Wetland and Jurisdictional Non-wetland Resources within Rose Canyon

ACOE, CDFG, and City of San Diego Jurisdictional  
Wetlands and Waterways, Regents Road Corridor (Rose Canyon) \_\_\_\_\_ Figure 4.3-5A

## RESPONSES

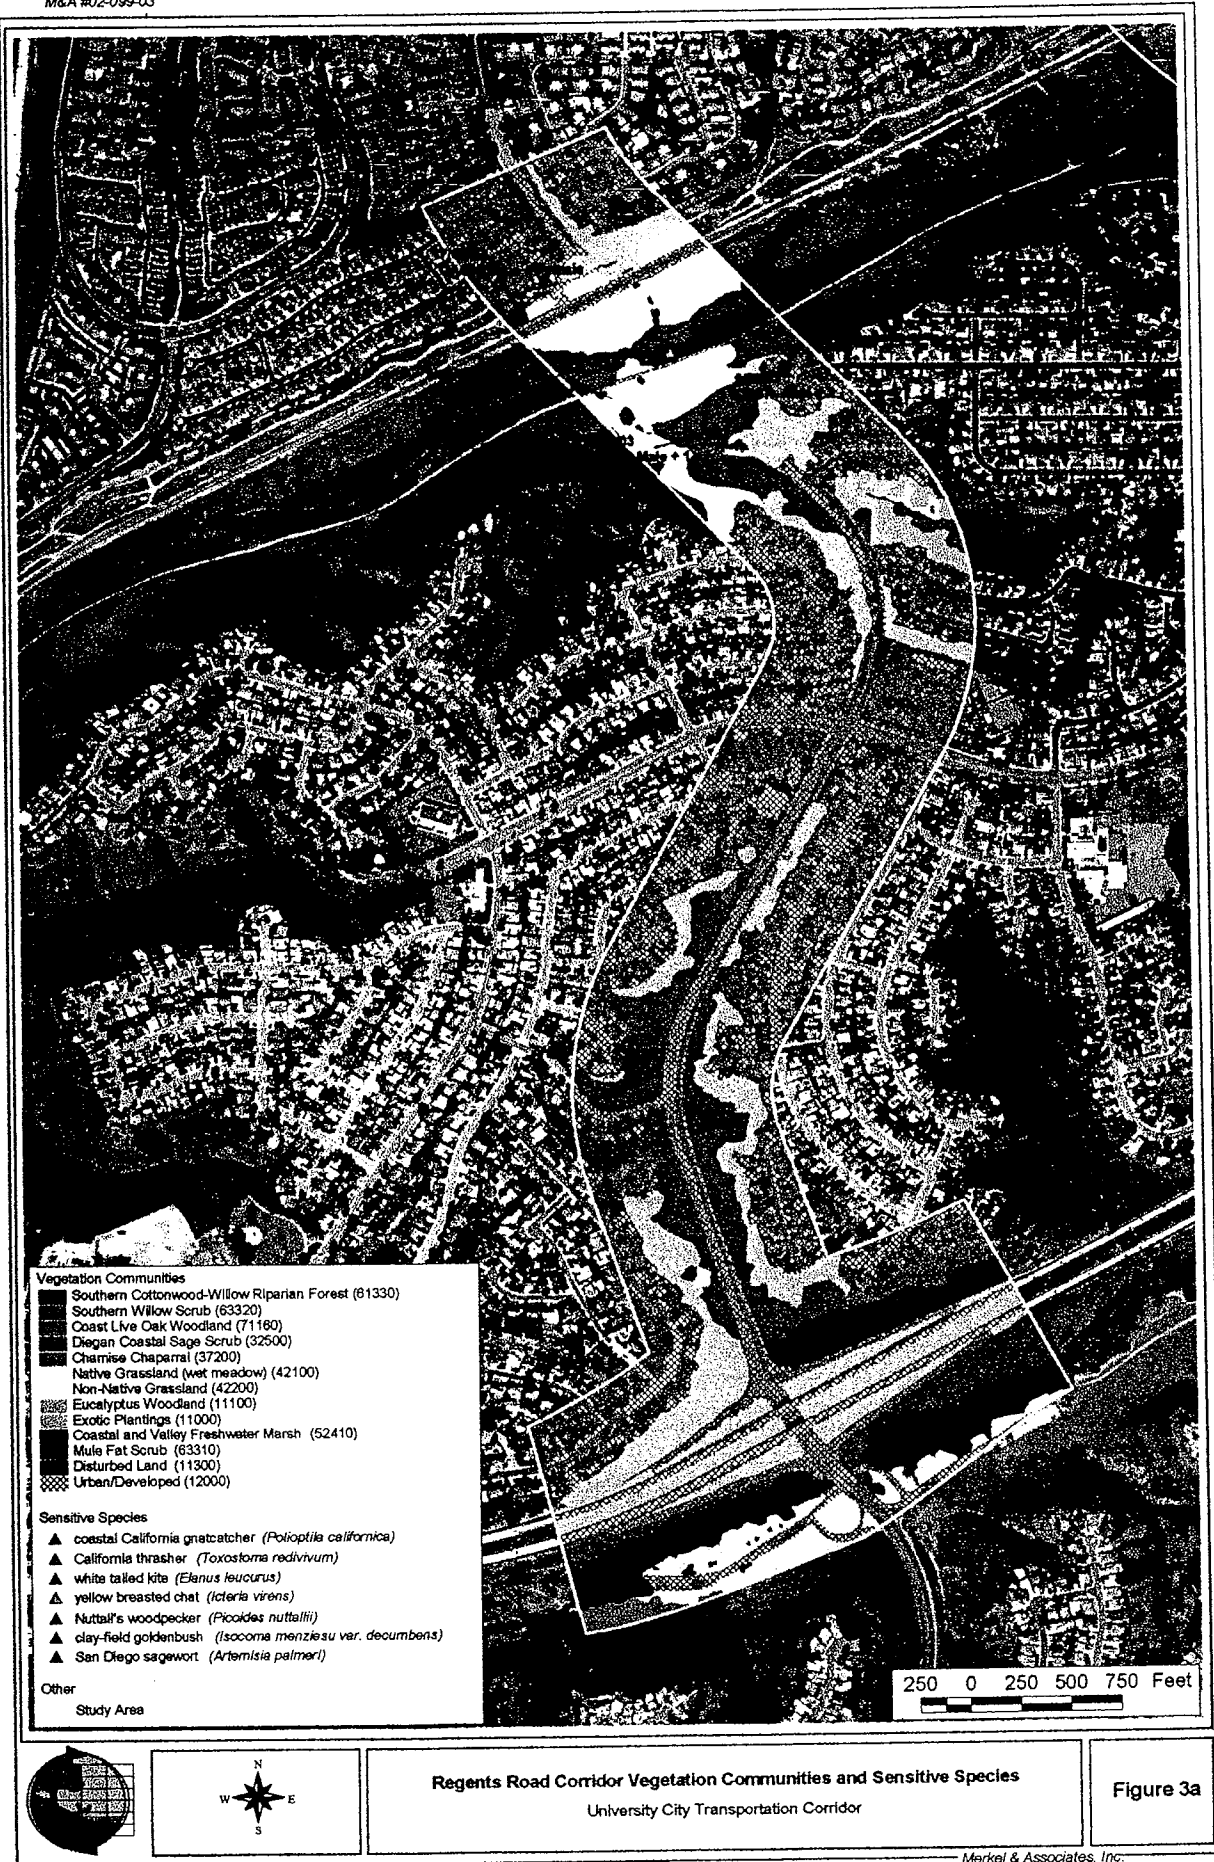
18.246 Of particular note in the habitat classification issues raised by the commenter is a concern regarding the classification of a low-lying swale along the Rose Canyon floor as native grassland rather than some other habitat type, alluding to the potential that the swale should potentially be considered a vernal pool. The particular site of concern was investigated extensively and is discussed on page 30 of the biological resource report and Appendix 3 of the report (EIR Appendix C). As indicated in the biological appendix, the swale is the result of isolation of lower sloping terrain behind an elevated trail constructed on a berm near the edge of the canyon floor. Water from rain runoff is impounded in this area, but at the time of the investigations, no evidence of wetland hydrology or hydric soils was noted. However, meeting the hydrophytic vegetation criteria during wetland delineation work, this area was mapped as a jurisdictional wetland by City of San Diego definition. It failed to be considered a jurisdictional wetland under state or federal standards. As such, it was mapped as a native grassland (wet meadow) since it was dominated by nearly 100% cover of beardless wild rye grass, with a sparse occurrence of exotic species. No vernal pool indicator plants were identified and the area is not a vernal pool based on flora, geologic origin, or hydrogeologic characteristics. Further, as indicated within the Biological Resources Report (EIR Appendix C, page 43), "A literature search of previously completed vernal pool surveys (Bauder 1986, U. S. Fish and Wildlife Service 1997, and City of San Diego 2004) revealed no historic locations of vernal pools within the study area or its immediate vicinity. The nearest extant vernal pools are over one mile to the northeast in the vicinity of Nobel Drive and MCAS Miramar."

Because of the characteristics of the swale, it is not suited to supporting vernal pool species and, as such, surveys for vernal pool species were not conducted in the pool. However, rare plant surveys of the area were conducted as part of the investigations. No rare plants were identified within this habitat.

On November 1, 2004, subsequent to significant winter rainfall events and flooding along Rose Creek, the project biologist, Adam Behle, was in Rose Canyon conducting mitigation site opportunities identification work. On this date, Mr. Behle was met by Ms. Debbie Knight who requested Mr. Behle to review the swale area and take photos to document ponding water and sediment marks on vegetation. Based on this visit and subsequent winter visits during the wetter than normal 2004-2005 winter, it was determined that this swale is subject to regular flooding by overbanking of Rose Creek. As such, the site would meet requirements to be considered a water of the U.S. under ACOE jurisdiction. The biological technical report and the FEIR have been modified to reflect this determination. Because the area was already considered to be a wetland under City definitions, the CEQA significance determination remains unchanged.
